Access Compliance Report

Public Rights-of-Way

(Curb Ramps)

Intersection ID: 10028585	Main Street: HOMESTEAD_GLEN_BV	Cross Street: N/A	Location: W
ADA ID: 18E11D5B611E	Ramp Type: Perp	Initial Pass/Fail: Fail	Overall Compliance: No
Severity Score: 21.25			
Codes/Mitigation Info/Possible Solution		Field Measurements/Component Compliance

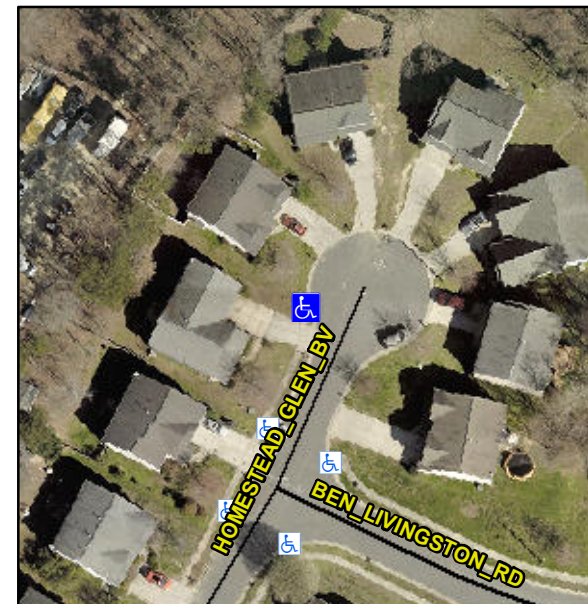
Not Found, R304.5.1, R304.2.2

Compliance	Description	Data	Compliance	Description	Data
N/A	Ramp Length (in)	45.5	No	Ramp Slope (%)	8.6
No	Ramp Width (in)	38.0	Yes	Ramp XSlope (%)	1.6
N/A	Flare Type LT	N/A	N/A	Flare Type RT	N/A
N/A	Flare Slope LT (%)	N/A	N/A	Flare Slope RT (%)	N/A
N/A	Flare Traversable LT?	N/A	N/A	Flare Traversable RT?	N/A
N/A	Landing Length (in)	N/A	N/A	DWS Provided?	N/A
N/A	Landing Width (in)	N/A	N/A	DWS Contrast?	N/A
N/A	Landing Slope (%)	N/A	N/A	DWS Length (in)	N/A
N/A	Landing X Slope (%)	N/A	N/A	DWS Full Width?	N/A
N/A	Landing Curb? (Y/N)	N/A	N/A	DWS Offset (in)	N/A
N/A	Shared Landing?	N/A			
N/A	Gutter Ponding?	N/A	N/A	Gutter Slope (%)	N/A
N/A	Gutter Lip Ht (in)	N/A	N/A	Gutter X Slope (%)	N/A
N/A	Painted X Walk1?	No	N/A	Painted X Walk2?	N/A
	X Walk 1 Direction	To E		X Walk 2 Direction	N/A
N/A	X Walk 1 Width (in)	N/A	N/A	X Walk 2 Width (in)	N/A
	X Walk 1 Slope (%)	3.3		X Walk 2 Slope (%)	N/A
	X Walk 1 X Slope (%)	1.3		X Walk 2 X Slope (%)	N/A

Remove & Replace Entire Ramp.
